As requested, attached are Ford comments, Alliance Comments and Ford comments to the TAR.

September 26, 2016

Alliance of Automobile Manufacturers Comments on Draft Technical Assessment Report:
Midterm Evaluation of Light-Duty Greenhouse Gas Emission Standards and Corporate Average
Fuel Economy Standards for Model Years 2022-2025 (EPA-420-D-16-900, July 2016)

Figure A-3: Comparison of IAV Gasoline Engine2 Map to NHTSA Base Engine Map

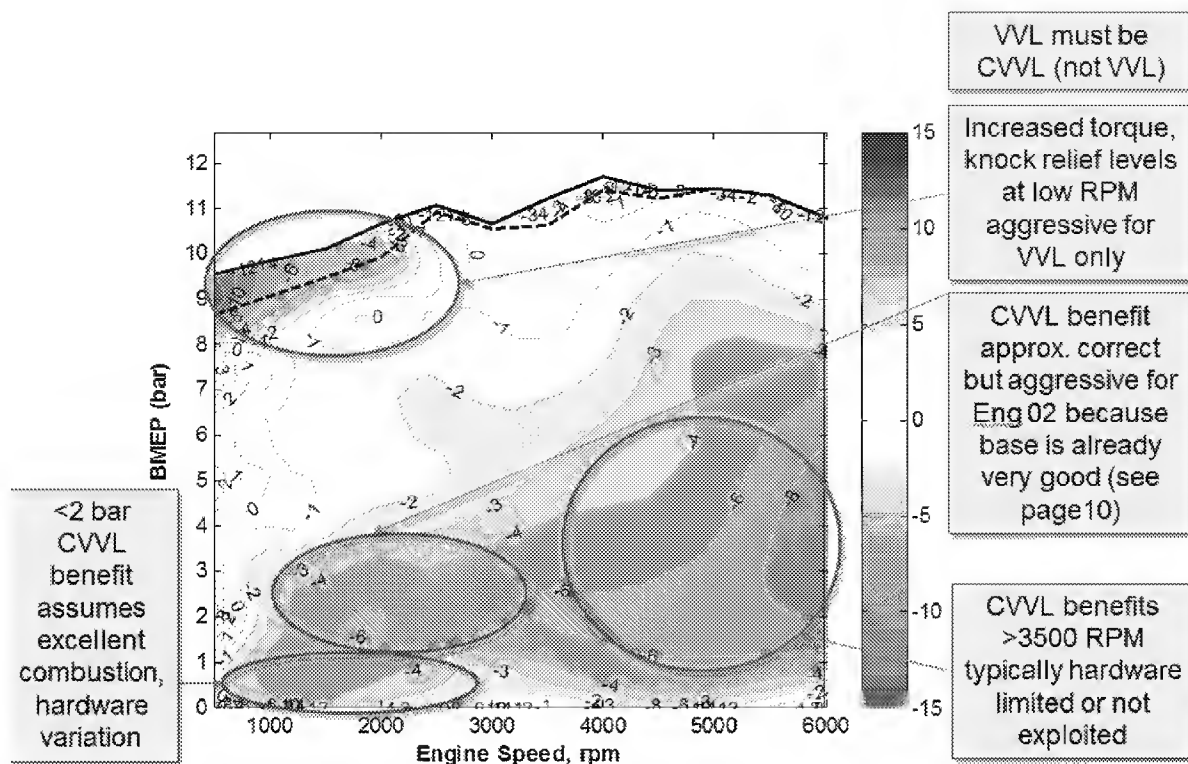
Figure A-3 compares the BSFC of the NHTSA Base Engine Map to the IAV Gasoline Engine2 Map with the key findings highlighted.

Figure A-4: Comparison of IAV Engine3 Map to IAV Engine2 Map

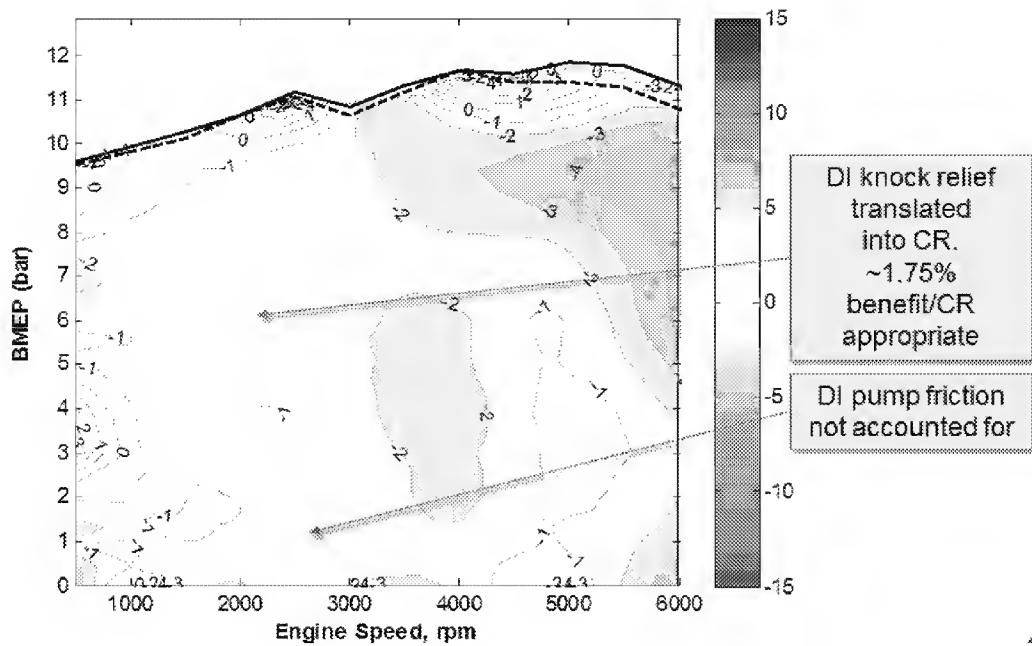
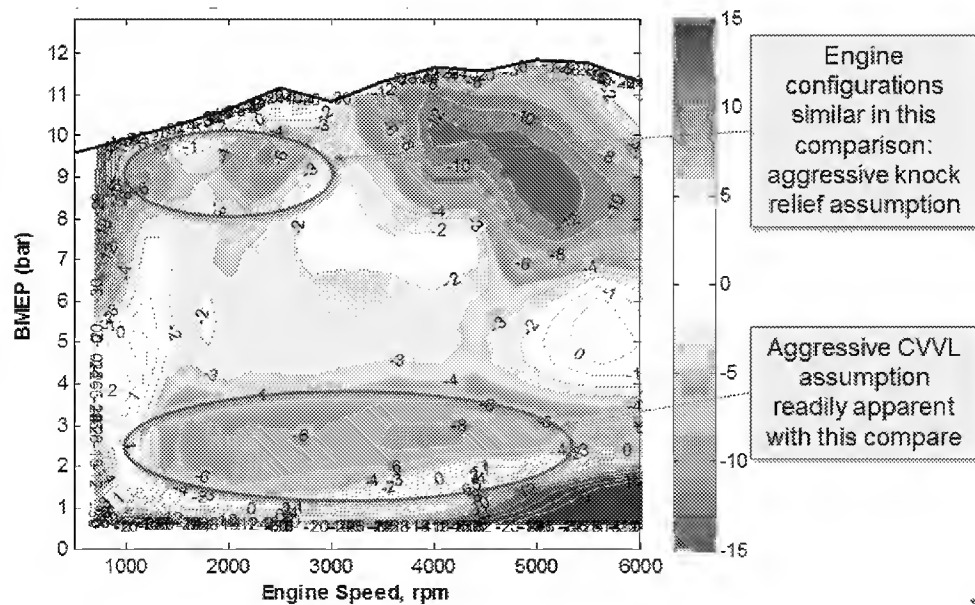
- The GDI pump friction isn't properly taken into account (Figure 1-4).
- Optimistic knock relief assumptions are used (Figure 1-4).
- Aggressive CVVL assumptions for low load operation were made across the speed band (Figure 1-5).
- The pumping work reduction is overstated, especially considering that the benchmark Honda engine used for comparison here is already a 2-Step VVL engine (Figure 1-5).

Figures A-4 and A-5 below capture the BSFC comparison with the key findings. Figure A-4 is a comparison to IAV Engine2 Map to isolate estimated GDI benefits. Figure A-5 is a comparison to the USCAR benchmarked Honda 2.4L engine with similar technologies.

Figure A-13: Comparison between IAV Gasoline Engine12 Map and IAV Gasoline Engine13 Map;
Displacement Change without Full Modeling Questionable

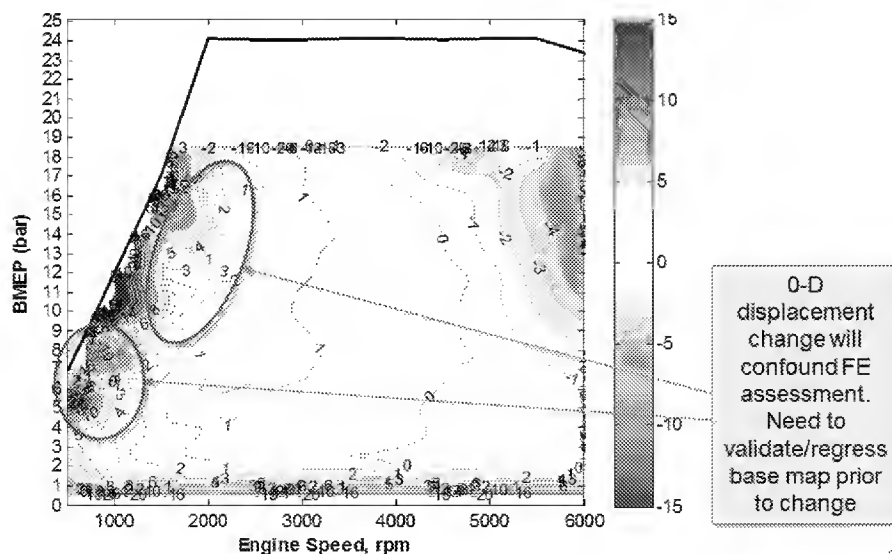
Figure A-13 captures the effect of a 0-D displacement change from 1.6L to 1.2L (downsizing effect).

Figure A-14: IAV Gasoline Engine14 Map - Aggressive Fuel Surface With Atypical Results

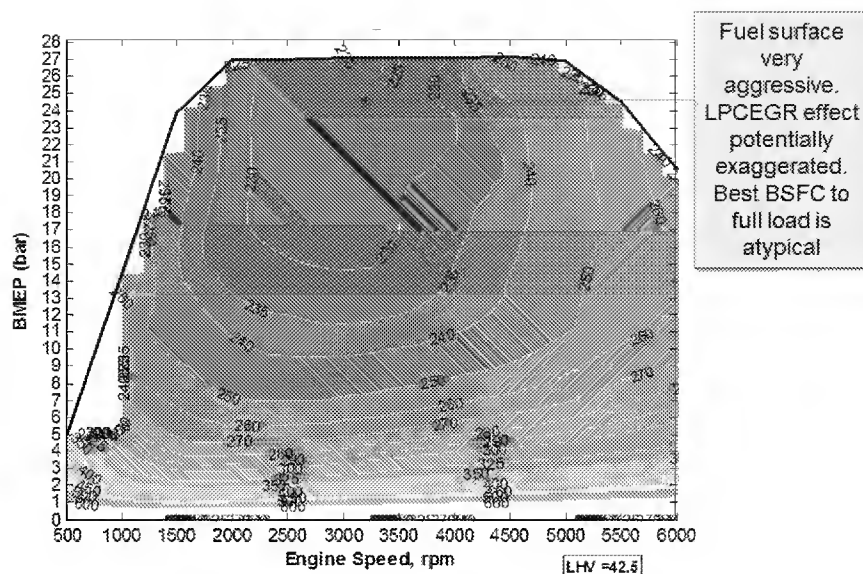
Figure A-14 below illustrates the effect of aggressive LPCEGR on the 1.0L 3-cylinder engine.

Figure A-15: Lumped Parameter Model compared to Test Data

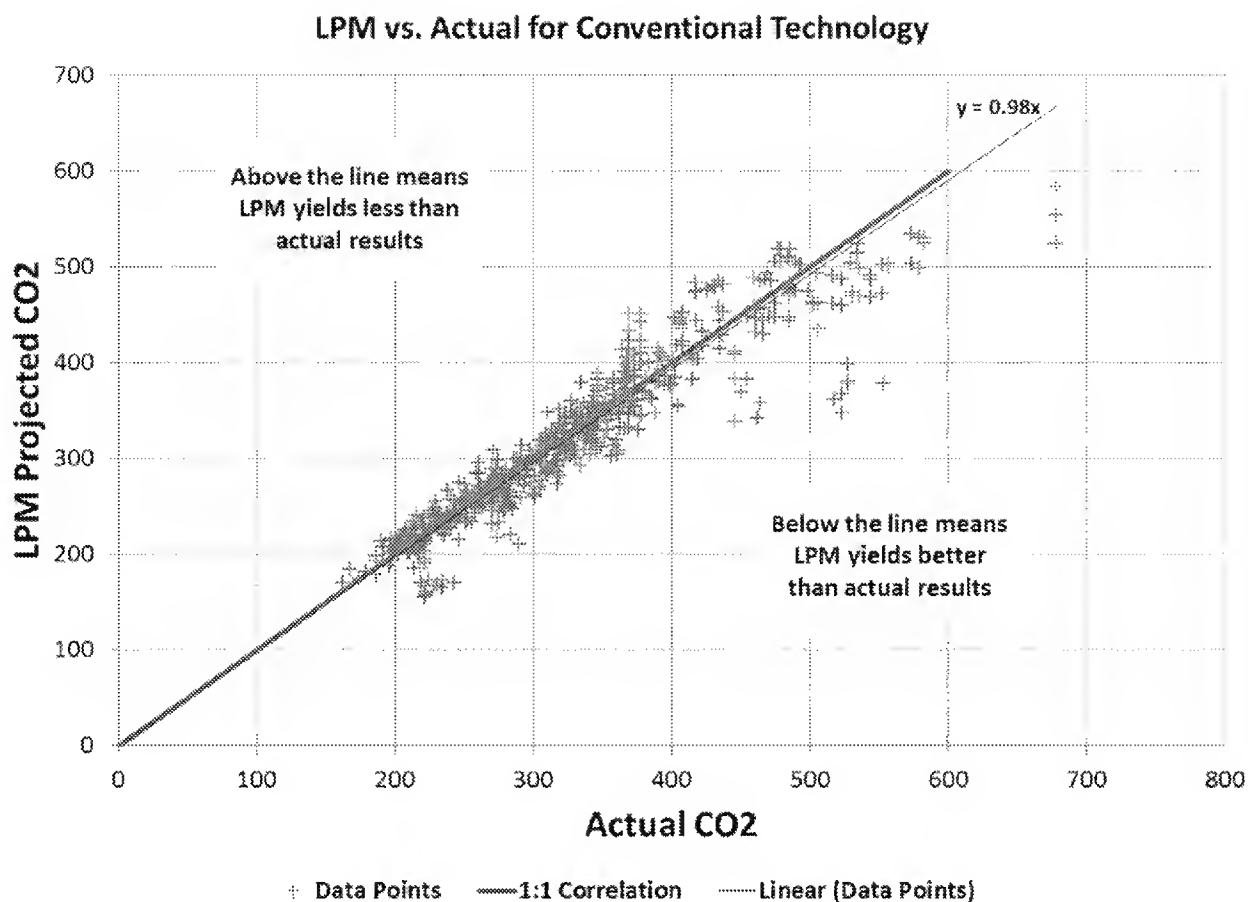
The results of this process, after sorting for conventional technologies (no hybrids, turbocharged engines, or eight-speed transmissions), are plotted below in Figure A-15. In this and the following figures, results below the line show data where the LPM predicted lower CO₂ than the vehicle actually emitted. Conversely, points above the line show when the vehicle was better than the LPM estimate. The standard error for this data is 31 g/mi, but the overall slope calculated as a best-fit line is about 2% from actual.

Figure A-16: Lumped Parameter Model compared to Test Data of Vehicles with 8-Speed Transmissions

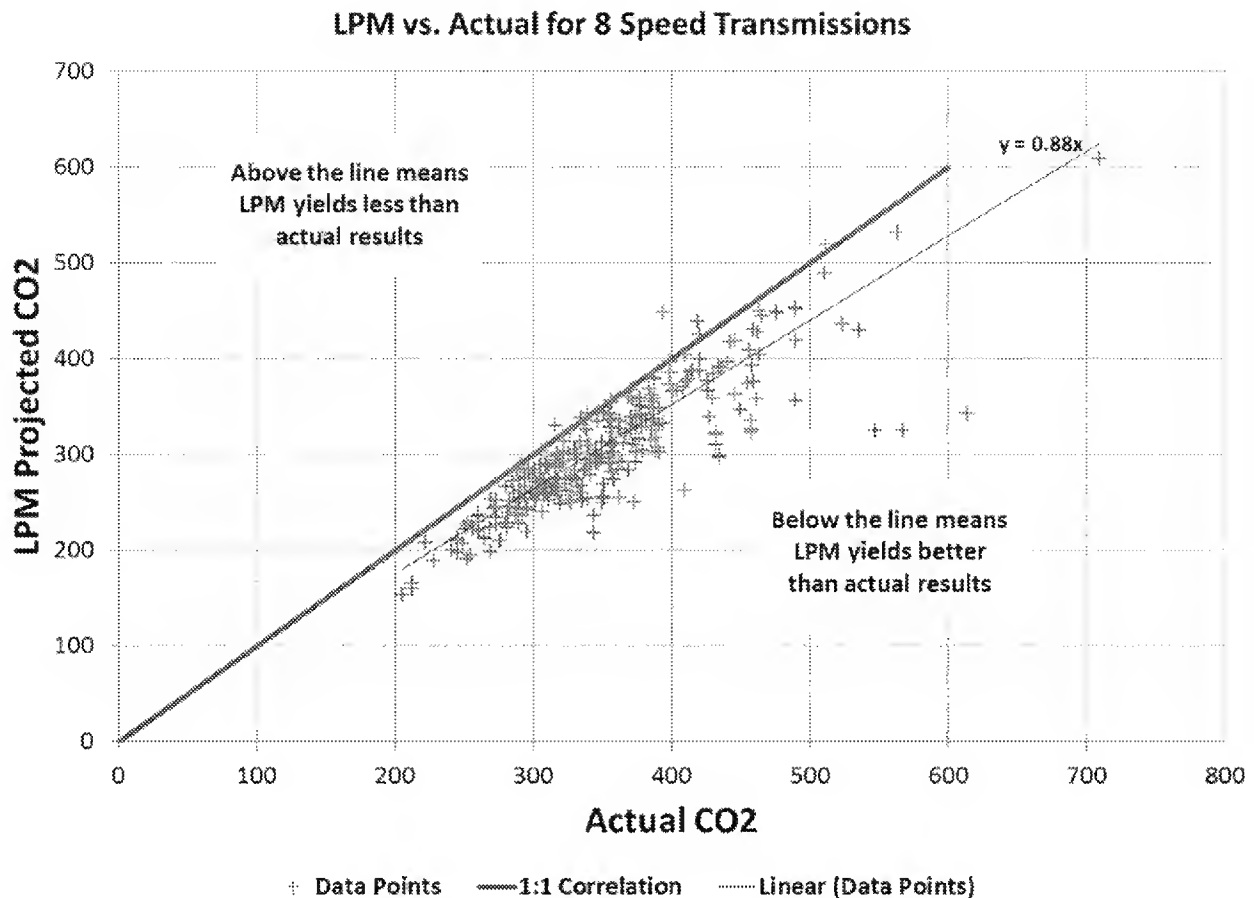
Figure A-16 shows the data after filtering for only eight-speed transmissions. Here the standard error has increased to 49 g/mi, but of greater concern is the change in slope of the best-fit line. The overall trend shows that the LPM is more optimistic by 12% than what manufacturers have, on average, been able to deliver. This is the powertrain technology, aside from variable valve timing, with the highest projected penetration (~90%) from the OMEGA model.⁷⁵

Figure B-1: Comparison of Mazda SkyActiv 2.0 L - EPA Data (96+ RON) vs. USCAR Data (91 RON)

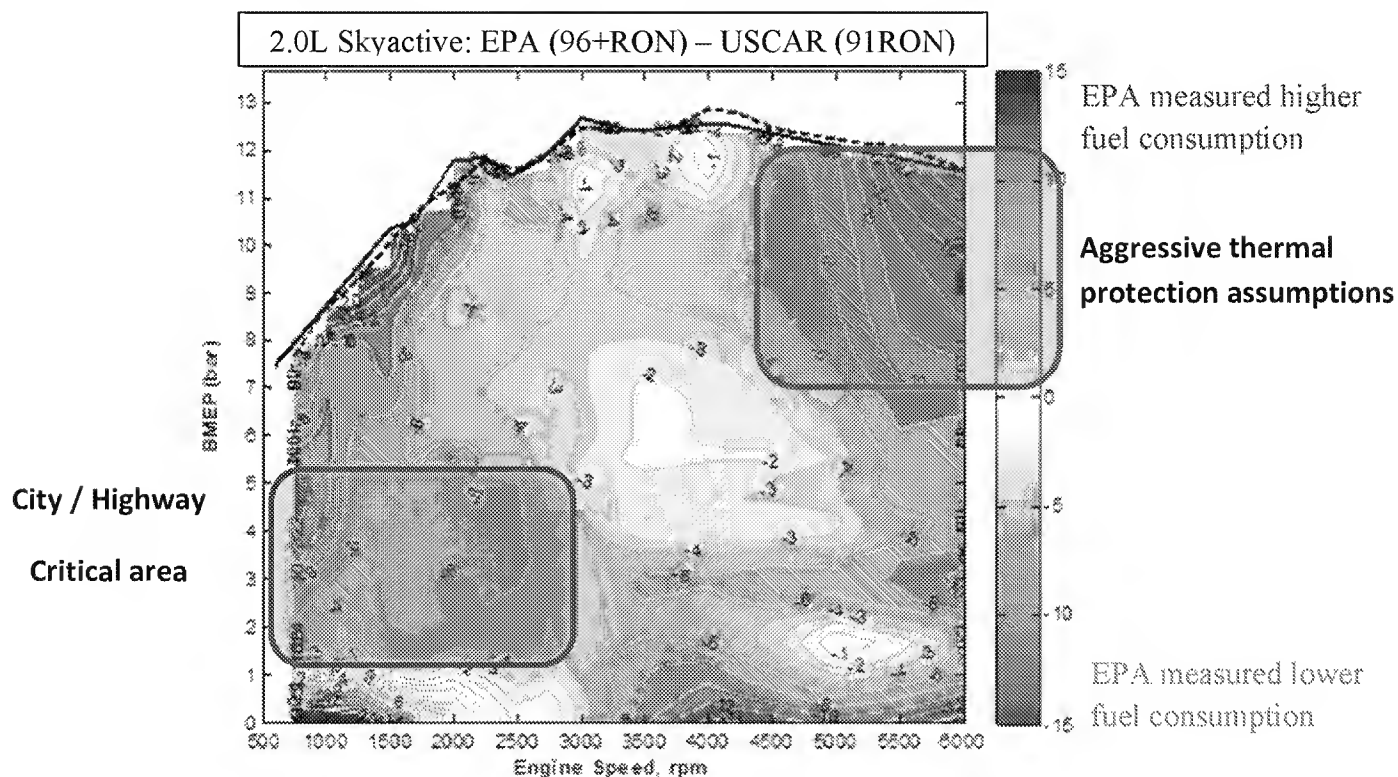
The differences between the USCAR and EPA fuel maps described in the paragraph above are shown in Figure B-1 below. The green areas in the plot (where EPA projects lower fuel consumption than USCAR) are due to knock limit improvements associated with EPA's use of premium fuel for benchmarking. The octane advantage can clearly be seen in the comparison, and results in engine fuel map benefits that cannot be achieved with market grade regular and Tier 3 certification test fuels.

Figure B-2: ATK2 Torque Curve Discrepancy between SAE and ALPHA^{98,99}

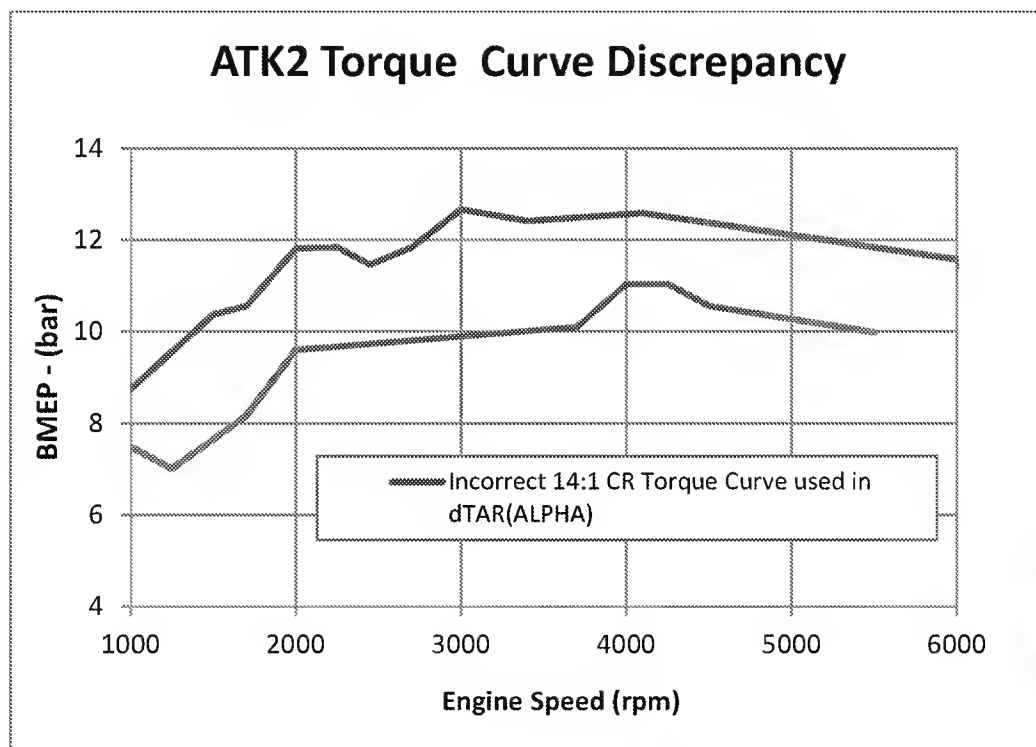
Additionally, it appears that there was a serious clerical error in translating the GT-POWER full load torque data to ALPHA which was then carried into the LPM's calibration. We note that in the SAE paper 2016-01-0565⁹⁶ the GT-POWER model correctly limited the full load torque of the engine due to knock onset. However, it is not clear that this significant reduction in torque was translated to the Advanced Atkinson Tech Package used in ALPHA simulation work which was subsequently used to calibrate the LPM model. This error incorrectly leads to exercising downsizing options because the performance metrics could theoretically be met with the torque that should have been limited as shown in SAE paper 2016-01-0565.⁹⁷ The net result is a large overestimation of the benefit with the Advanced Atkinson Tech Package. The modeled performance would be further degraded if correct CEGR assumptions were used as discussed below. Figure B-2 compares the two torque curves, baseline Atkinson, and the Advanced Atkinson Tech Package.

Figure B-3: MY 2025 Advanced Atkinson Tech Package Penetrations in the EPA Control Case Central Analysis with ICMs¹⁰²

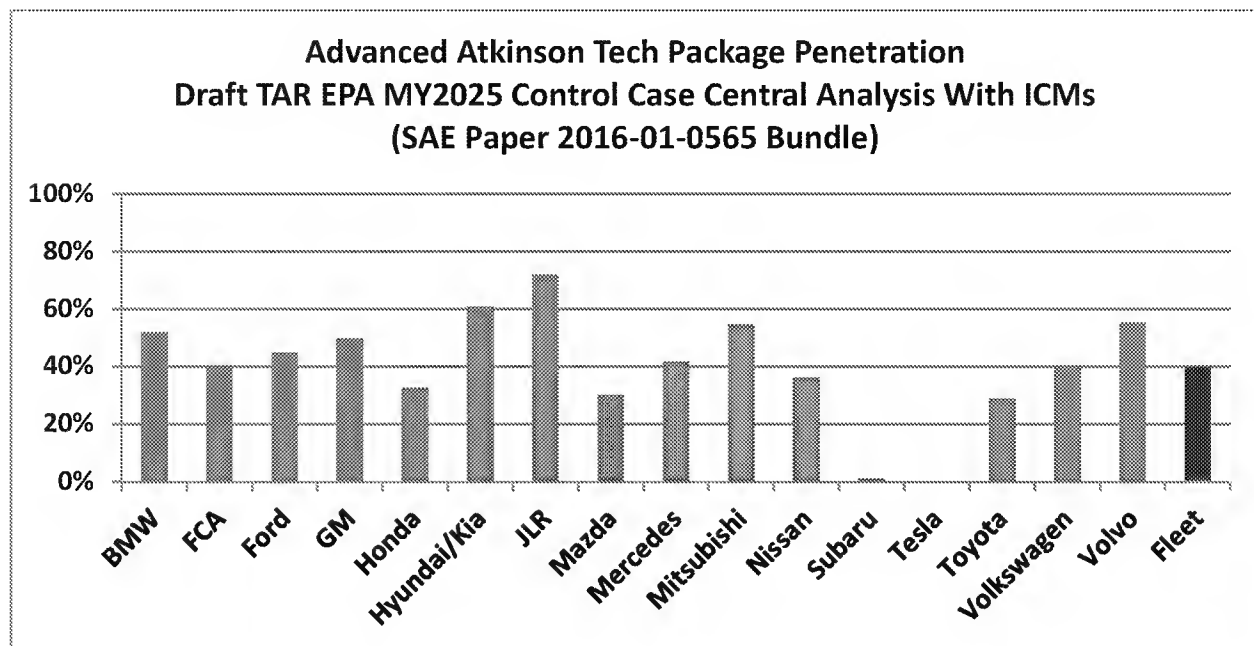
For the Draft TAR, EPA modeled that almost every automaker (except Tesla which only produces battery electric vehicles) will adopt the Advanced Atkinson Tech Package by MY2025 (Figure B-3), and that a number of manufacturers will exceed 50% penetration of this technology

Figure E-9: Chapter 4 IHS/Polk Sales Projections from the Draft TAR²⁴⁹

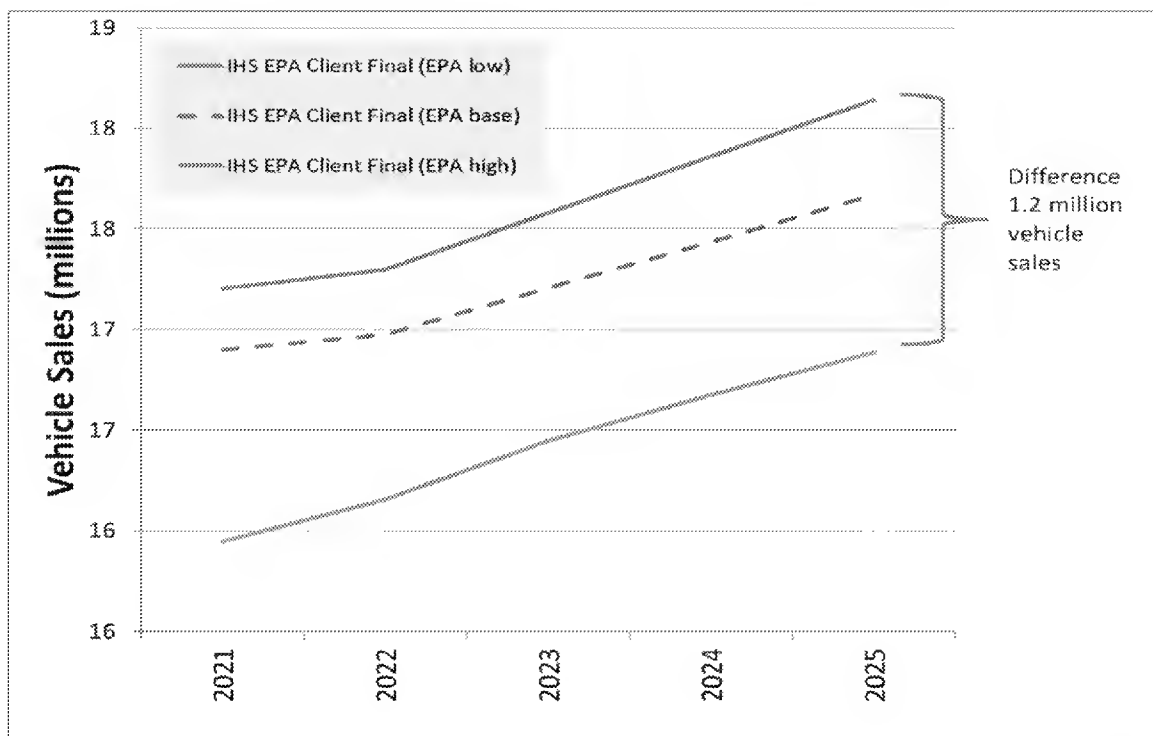
The IHS/Polk spreadsheet data from the docket²⁴⁶ (which assume the standards stay fixed from 2021 onwards) do project a decrease in sales due to the effect of higher gasoline prices, showing a difference of 1.2 million vehicle sales between the projections of EPA high gasoline prices and EPA low gasoline prices.²⁴⁷ Since the IHS/Polk projections hold standards constant at 2021 levels, they do not provide information on what sales might be with the application of MY2025 standards.²⁴⁸ The following graph (Figure E-9) plots these sales projections from the IHS/Polk spreadsheet:
